Tweed Mall Master Plan

Sewerage and Water Network Capacity Assessment and Site Servicing Report

03 | 20 December 2023

Figure 4 Indicative future water mains to accommodate the Tweed Mall redevelopment (provided by TSC)

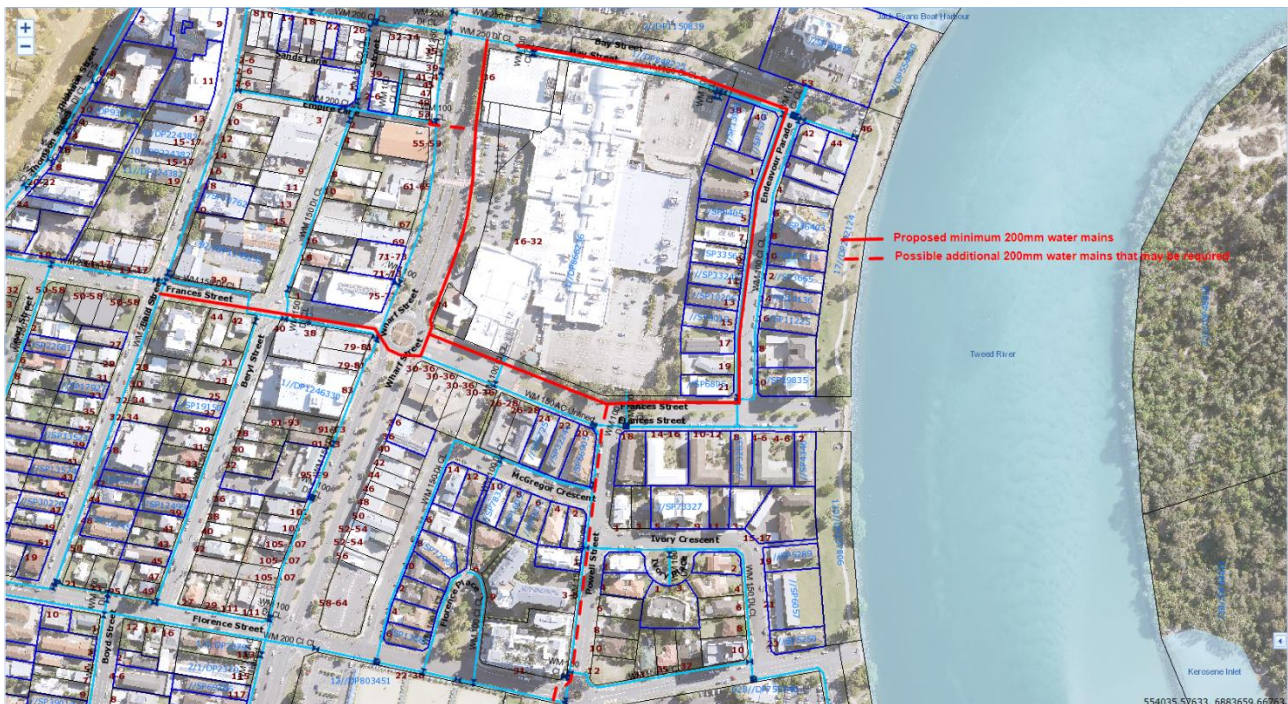
1. A DN200 minimum (TBC) water main is to be provided around the perimeter of the development (see figure 4 below). This will involve a new main along the eastern road verge of Wharf St and upgrade of the existing mains on Bay St, Endeavour Parade and Frances St.

2. A DN200 minimum (TBC) main from Frances St to connect to the existing DN200 main in Enid St to improve capacity in the network. Future hydraulic modelling (conducted by TSC) is to inform any additional required works to ensure standards of service are maintained.

Figure 7 Preferred location of new SPS (provided by TSC)

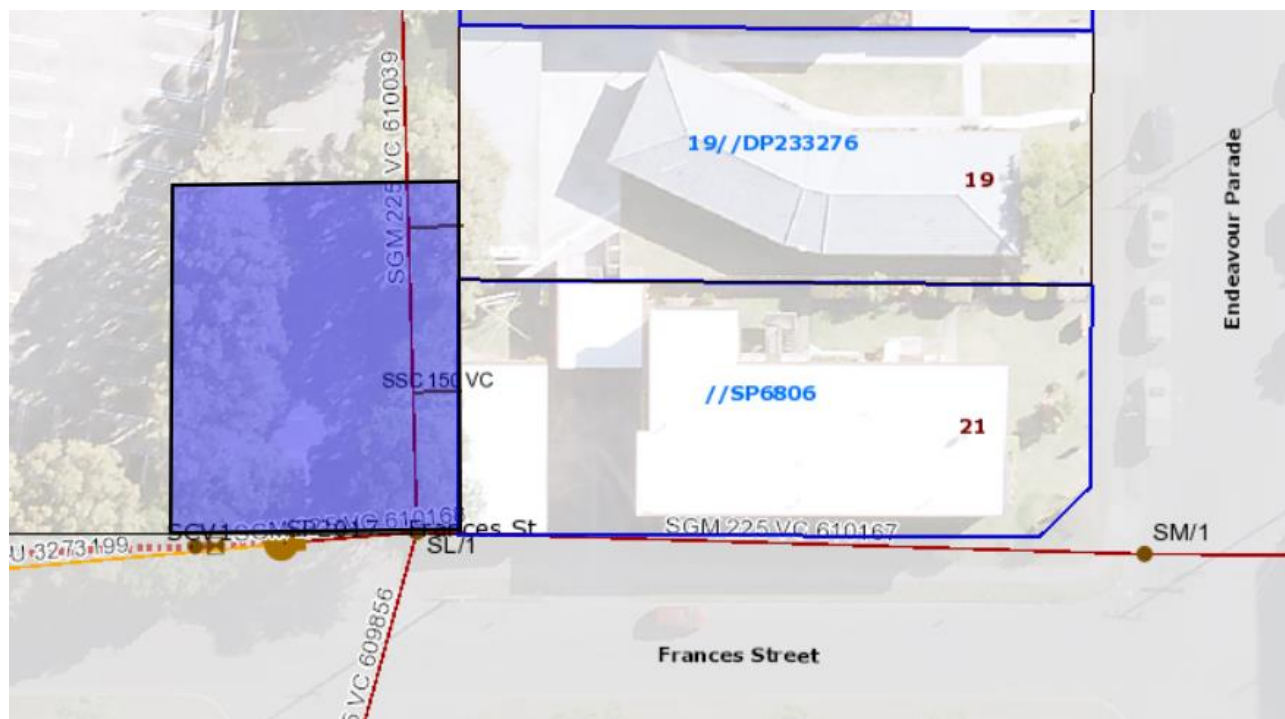
1. The existing pumps at SPS2017 Frances St require significant upgrade to accommodate ultimate development flows. The existing design duty of SPS2017 is 30 L/s, with future design flows from the Tweed Mall redevelopment and surrounding local catchment estimated to be circa 75 L/s at ultimate development. The existing location of SPS2017 is highly constrained and TSC would be seeking to acquire land from the developer (approx. 20m x 25m) to construct the new pump station (see Figure 7).

Figure 1. Indicative future water mains to accommodate the Tweed Mall redevelopment

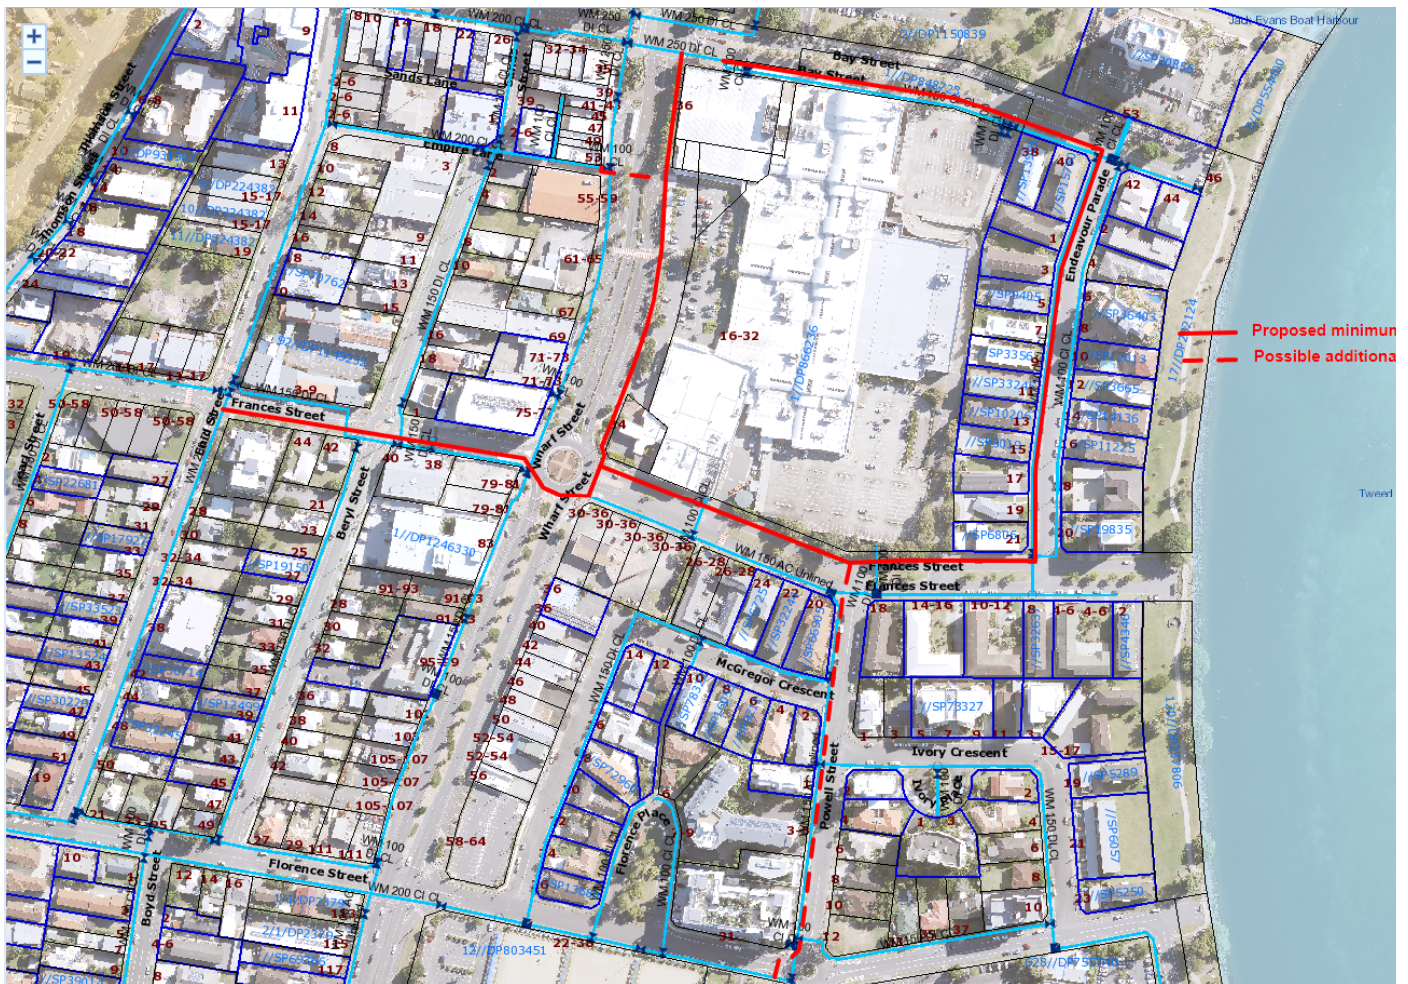
1. A DN200 minimum (TBC) water main is to be provided around the perimeter of the development (see figure 1). This will involve a new main along the eastern road verge of Wharf St and upgrade of the existing mains on Bay St, Endeavour Parade and Frances St.

2. A DN200 minimum (TBC) main from Frances St to connect to the existing DN200 main in Enid St to improve capacity in the network. Future hydraulic modelling (conducted by TSC) is to inform any additional required works to ensure standards of service are maintained.

Figure 2. Preferred location of new SPS

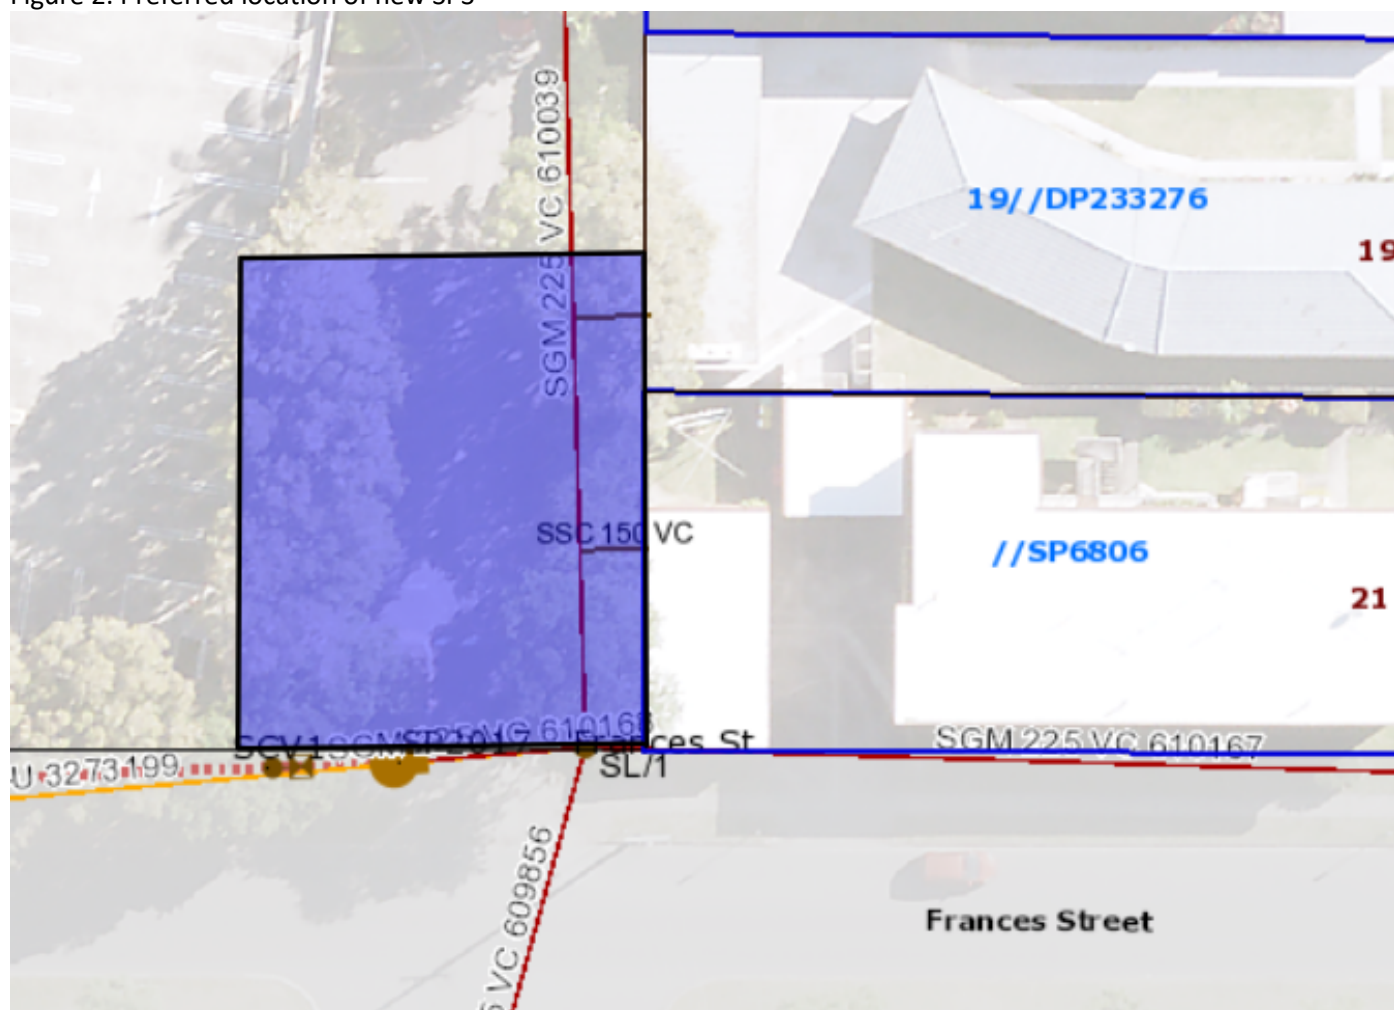
1. The existing pumps at SPS2017 Frances St require significant upgrade to accommodate ultimate development flows. The existing design duty of SPS2017 is 30 L/s, with future design flows from the Tweed Mall redevelopment and surrounding local catchment estimated to be circa 75 L/s at ultimate development. The existing location of SPS2017 is highly constrained and we would be seeking to acquire land from the developer (approx. 20m x 25m) to construct the new pump station (see figure 2).

Figure 3. Possible alignment of new DN250 (TBC) SRM2017

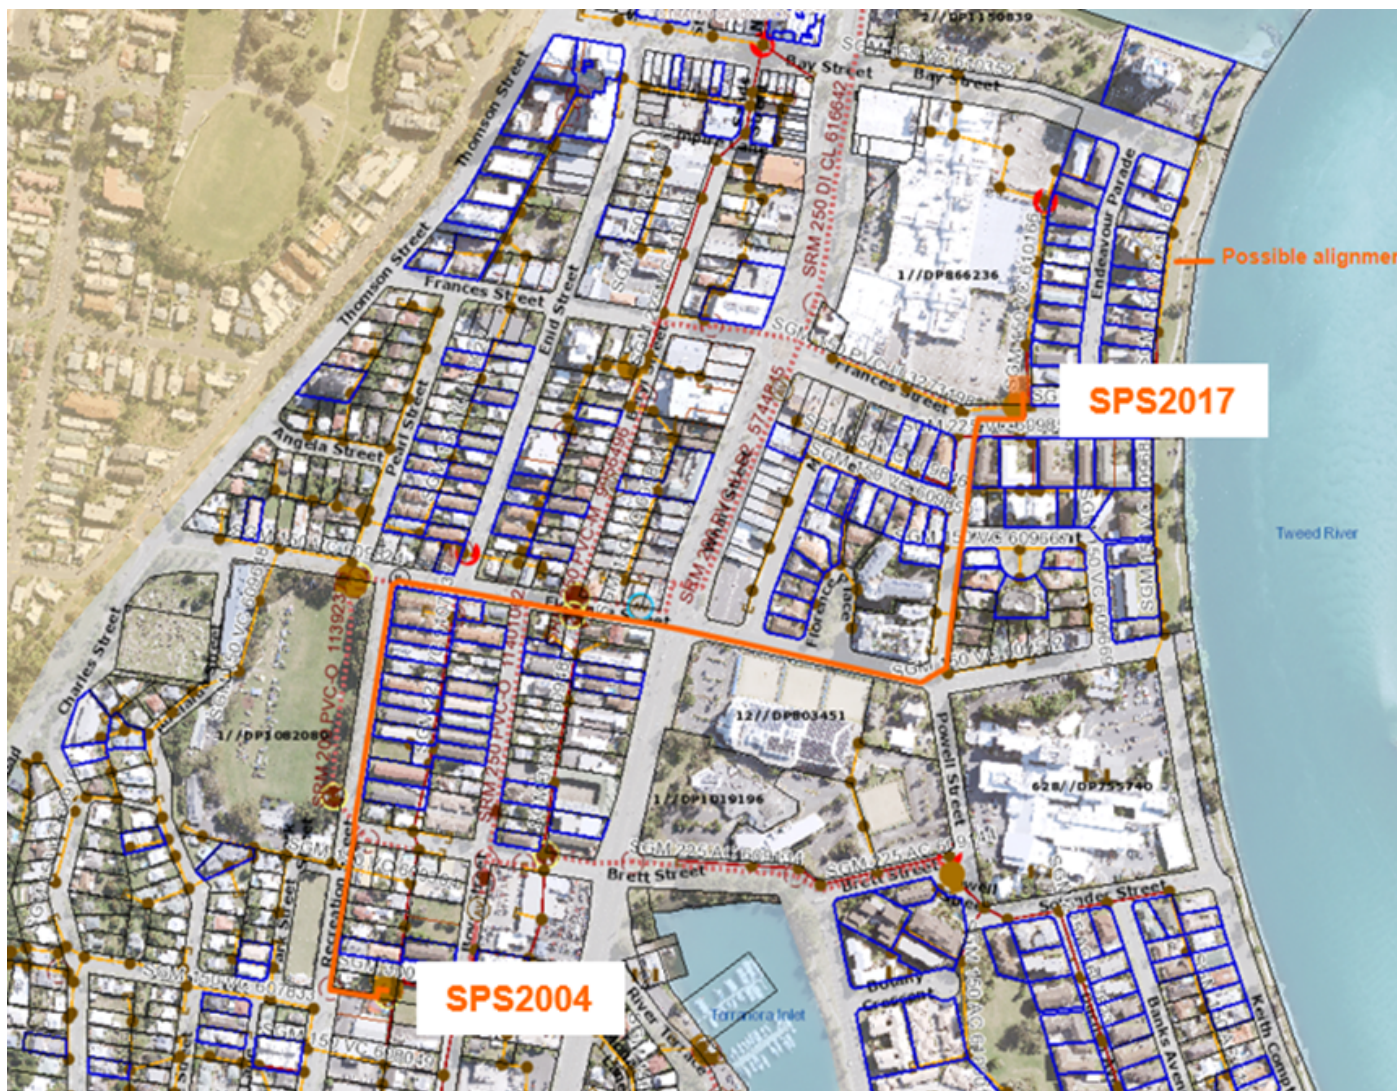
2. The future upgraded capacity at SPS2017 could not be accommodated within the existing downstream network. A new dedicated DN 250 rising main to the future regional SPS2004 Recreation St would be required (see figure 3). Flows from SPS2017 could not be accommodated at SPS2004 until SPS2004 upgrade and associated downstream rising main works are complete.
